Mill Cottage, Clymping Mill

Addendum to
Planning & Heritage Statements

Mill Cottage - Addendum to Planning & Heritage Statements in support of changes to previously approved applications CM/22/18/L and CM/6/19/HH

Plate 3a & 3b Internal door opening in east gable wall of old range of Mill Cottage

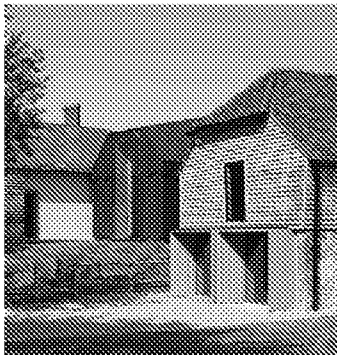
The Assessment of Significance describes most of the existing windows to be poor quality UPVC windows. Previous proposal was to replace them with timber windows with single horizontal bar and 14mm slimline glazing. It is not clear what style they are alluding to as there is no record of the windows that preceded the UPVC windows. However assumptions can be made that the east / north range of 1920/30's period would have had modern windows out of keeping with 19th century mill buildings associated with the historic Smock Mill, and hence of lesser value. The older east range was originally an agricultural building and part of the 19th century mill group but it also has UPVC replacement windows. There is photographic record of the window in the east gable wall of the east range dated early 1900's that shows a window with shutters – see plate 2, and from the internal stripping out works in this room the brick corbels framing the window drop to the ground internally suggesting that an earlier door opening existed here – see plates 3a & 3b.

This revised application proposes a simplified window fenestration which adopts a more utilitarian aesthetic, more in keeping with the former mill buildings. The horizontal bar is removed and the double glazed units are 24mm to provide better thermal insulation and protection from climate and theft. The revised windows are an enhancement to the current UPVC windows, and with little or no evidence of previous window treatments we think it appropriate that the aesthetic is a simple, contemporary interpretation of the utilitarian nature of the original mill buildings – see appendix plate 4
